SUBJECT: SAFETY EVALUATION REPORT FOR ENVIRONMENTAL QUALIFICATION OF
SAFETY-RELATED ELECTRICAL EQUIPMENT

Millstone Station Unit 1

SAFETY EVALUATION REPORT BY THE
OFFICE OF NUCLEAR REACTOR REGULATION
EQUIPMENT QUALIFICATION BRANCH
FOR NORTHEAST NUCLEAR ENERGY COMPANY
MILLSTONE 1
DOCKET NO. 50-245

ENVIRONMENTAL QUALIFICATION OF SAFETY-RELATED ELECTRIC EQUIPMENT

Figure 10. Drywell Pressure
Response to a 0.10 ft² MSLB

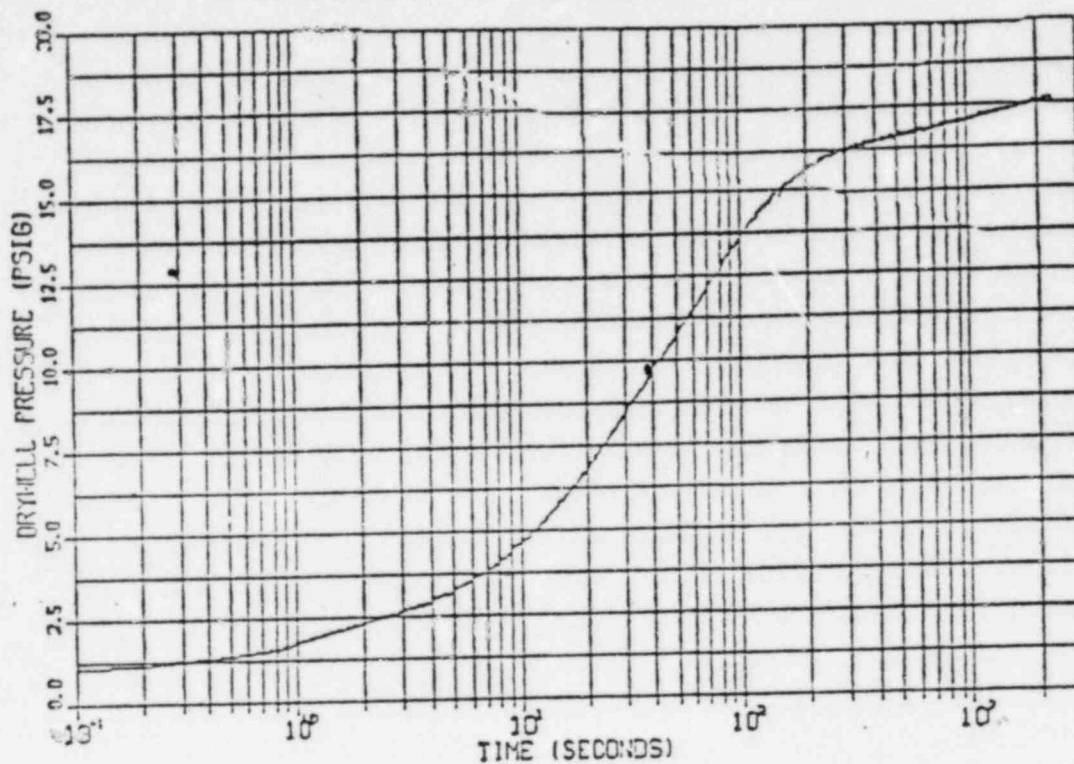
The staff has reviewed this concern and concludes that the drywell temperature profile for the 0.1 ft.² MSLB should either be extrapolated at a temperature of 320°F out to 6-hours and then reduced to follow the generic curve in Figure C-1 of NUREG-0588, out to 24-hours, or provide a plant specific analysis (See Figures 10 and 11, attached).

Figure 10. Drywell Pressure
Response to a 0.10 ft² MSLB

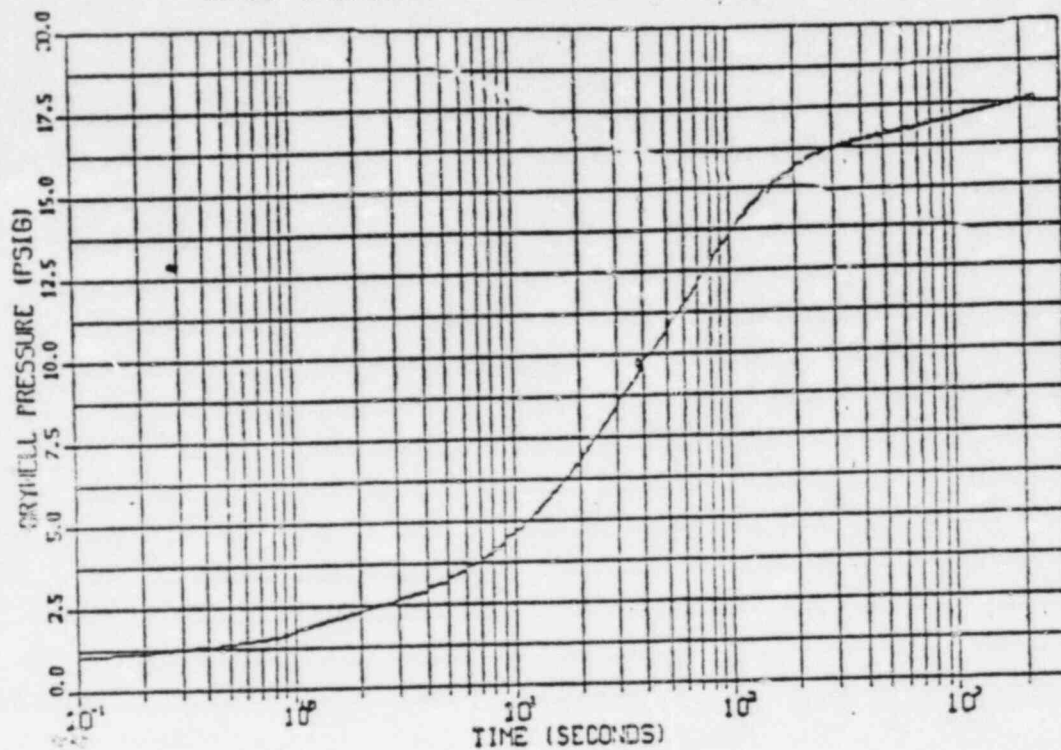
The staff has reviewed this concern and concludes that the drywell temperature profile for the 0.1 ft.² MSLB should either be extrapolated at a temperature of 320°F out to 6-hours and then reduced to follow the generic curve in Figure C-1 of NUREG-0588, out to 24-hours, or provide a plant specific analysis (See Figures 10 and 11, attached).
